Memorandum

TO: Common Council
FROM: Greg Keil, CDD *CK*
Date: June 11, 2009
RE: Outdoor Alcohol Beverage Permit – Sliders

City of Menasha
Application for Outdoor Extension of Retail "Class B", Class "B"
And/or "Class C" License

Siders

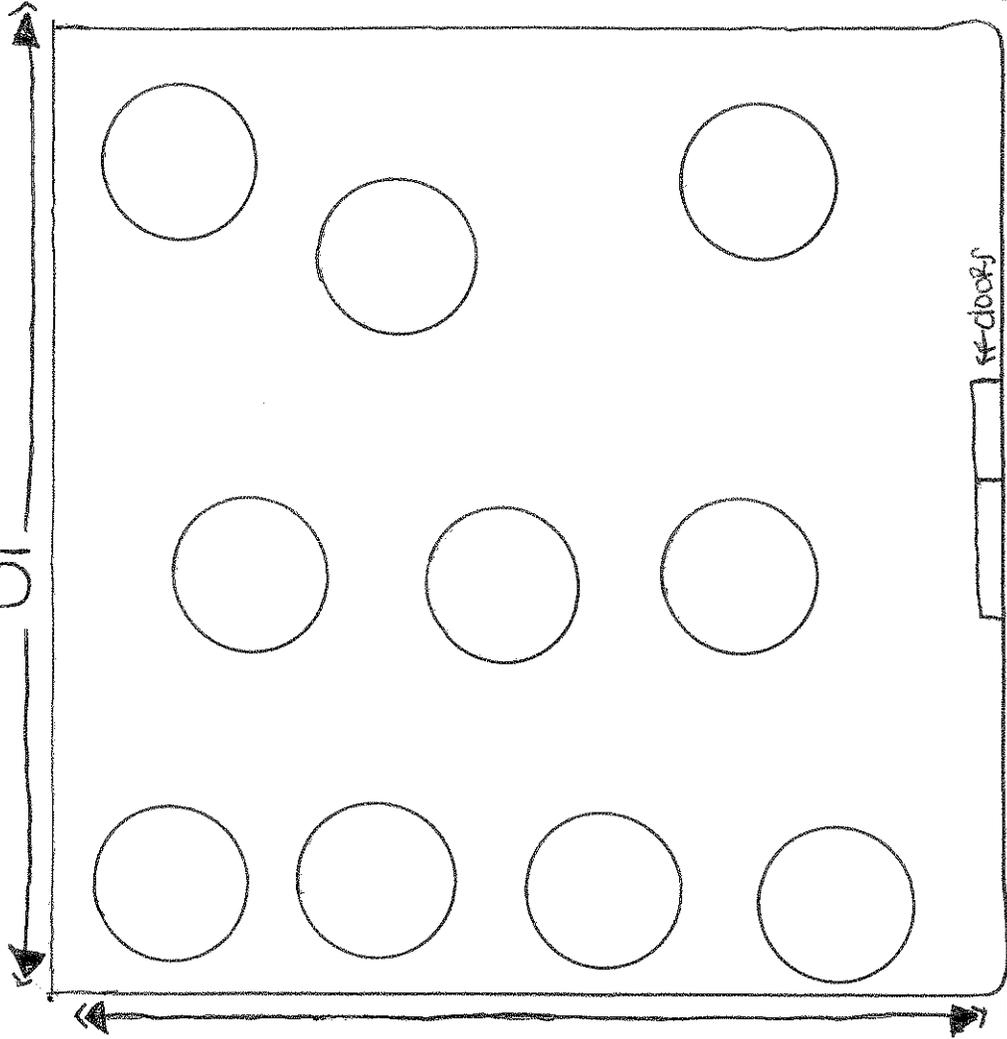
The Outdoor Alcohol Beverage Permit application from Slider's does not fully comply with ordinance requirements in as much as the existing fence does not meet the minimum height requirement of 42 inches (it is 32 inches). The outdoor seating area and fence were constructed as part of the original Sabini's Restaurant. No alcohol was served on the patio at that time. Also, the current ordinance dealing with outdoor service was not in effect at that time.

Should the Common Council elect to waive the fence height requirement, it is my recommendation that it do so based on findings specific to this site, e.g.:

- The fence was installed prior to the effective date of the current ordinance
- It is not practical to increase the height of the fence to meet ordinance requirements
- The outdoor seating area is not located in close proximity to adjoining properties
